Stand Golf Club, Whitefield Response to Comments from Bury Council

1. BTG Eddisons has been instructed by Westshield Ltd to advise on the traffic and transport issues relating to a planning application for redevelopment at Stand Golf Club in the Whitefield area of Bury.
2. A planning application (App Ref No: 72578) has been submitted for the re-location of the clubhouse from Ashbourne Grove (Site A) to land to east of Ringley Road (Site B), and the erection of 45 no. dwellings and 60 no. retirement-living apartments in Site A. This was accompanied by a Transport Assessment (TA).
3. Comments on the application were provided by the highway authority and a response to these comments provided.
4. The highway authority has provided further comments, and the following provides a response to these.

Forward Visibility

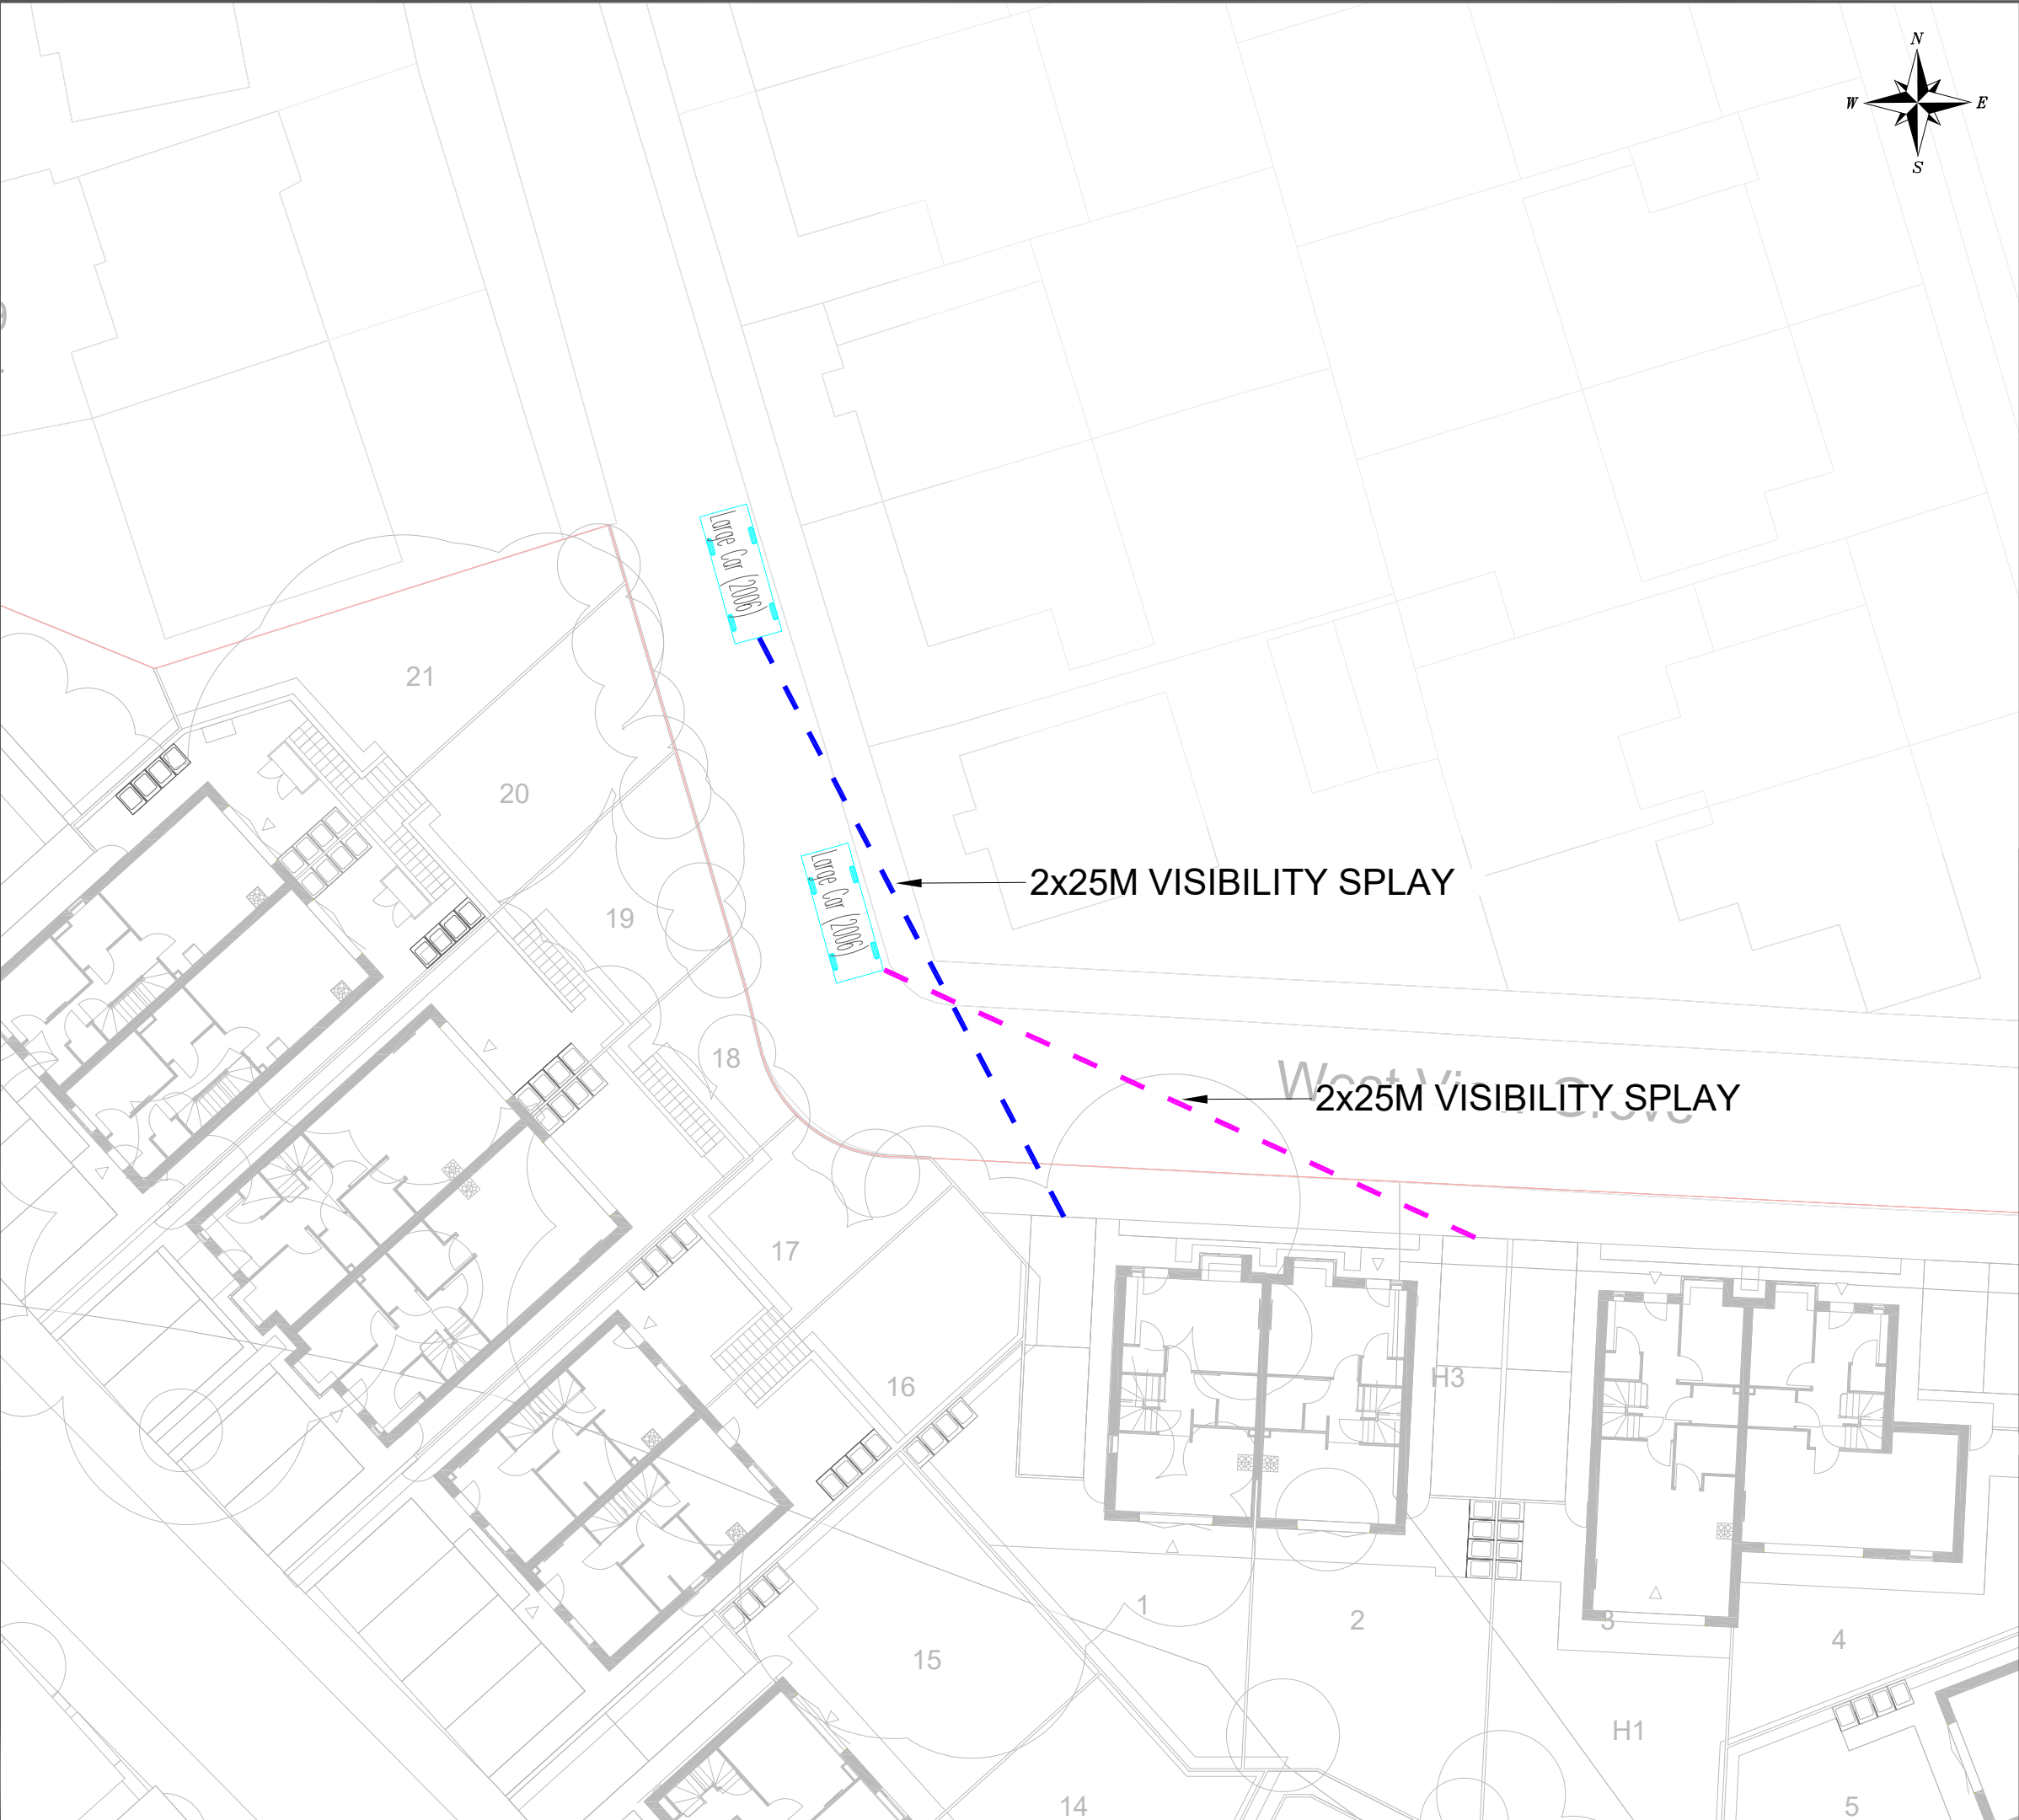
14. Comment: *'Forward visibility approaching the accesses/driveways for Plots 1 – 4 has not been properly assessed, or visibility from these driveways properly considered due to the proximity of these new access points to the existing near 90 degree bend in West View Grove.'*

17. In order to advise the highway authority, 25m sightlines have been illustrated from a southbound vehicle to the driveways of plots 1 and 2; 25m is the requisite forward visibility for a vehicle travelling at 20mph, though given the road alignment, vehicles will negotiate the bend at speeds lower than this.
18. Regardless, as demonstrated on the plan included at **Appendix 1**, 25m forward visibility is available.
19. Comment: *'Provision of a 2.0m footway does not address this issue – this facility is required to enable safe pedestrian access to these plots regardless of the visibility issues raised.'*
20. Given the low traffic nature of a private driveway, the x-distance required for visibility is 2m. As well as facilitating pedestrian access, the provision of a 2m footway therefore also allows this x-distance to be achieved.
